## UNITED STATES PATENT AND TRADEMARK OFFICE

APPLICATION NO.	FILING DATE	FIRST NAMED INVENTOR	ATTORNEY DOCKET NO.	CONFIRMATION NO.
10/595,196	01/26/2007	John A. Gelardi	CPG 03-15 MB	4380
38235 7590 03/24/2009 MEADWESTVACO CORPORATION ATTN: IP LEGAL DEPARTMENT 1021 Main Campus Drive Raleigh, NC 27606				
EXAMINER GRANO, ERNESTO ARTURIO				
ART UNIT		PAPER NUMBER		
3728				
NOTIFICATION DATE		DELIVERY MODE		
03/24/2009		ELECTRONIC

### Office Action Summary

### **DETAILED ACTION**

**FIG. 1**  
 (examiner modified)

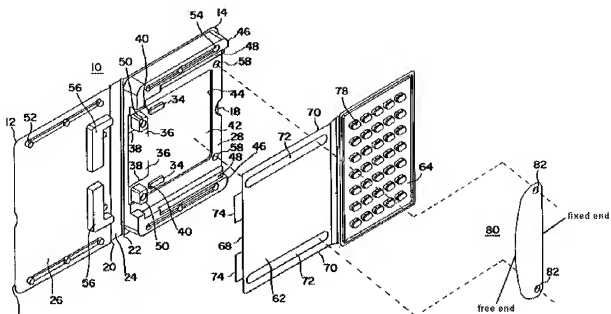
In re claim 1, Buss discloses a storing and dispensing system, comprising: a blister card 62/64 holding items 90 to be dispensed, said card comprising at least one receiving aperture 72; a case 10 defining a void therein; and at least one detent extending from the case 10 toward said void, a given detent 52 being configured for engaging a given receiving aperture 54.

In re claim 23, Buss as applied to claim 1 above, discloses a release 18 and 16 proximate to said given detent configured to disengage said engaged given receiving aperture 54 and said given detent 52.

In re claim 24, Buss as applied to claim 1 above, discloses a retainer 82 located within said void having a fixed end and a distal free end, said free end configured to

interlock with a given receiving aperture 58 and interrupt the separation of said card 62/64 from the case 10.(see column 4, lines 47-64)

In re claim 13, Buss as applied to claim 10 above, discloses wherein said retainer comprises a releasable, inwardly-extending second appurtenant 34. (see figure 1 above)

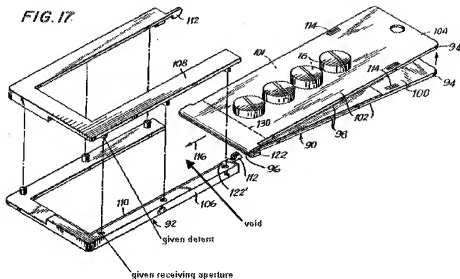
In re claim 1, Kotyuk discloses a storing and dispensing system, comprising: a blister card 90 holding items 16 to be dispensed, said card 90 comprising at least one receiving aperture 114; a case 92 defining a void therein; and at least one detent 112 extending from the case 92 toward said void, a given detent being configured for engaging a given receiving aperture. (see figure 17 above)

In re claim 26, Kotyuk as applied to claim 1 above, discloses wherein the engagement of the at least one detent 112 with a corresponding receiving aperture 114 locks said card in an inserted position within the case 92. (see figure 18)

In re claim 13, Kotyuk as applied to claim 10 above, discloses wherein said retainer 122' comprises a releasable, inwardly-extending second appurtenant 112(near122'). (see figure 17 above)

In re claim 28, Kotyuk as applied to claim 10 above, discloses wherein a given retainer 112(near122') is a spring element. (see figure 17 above)
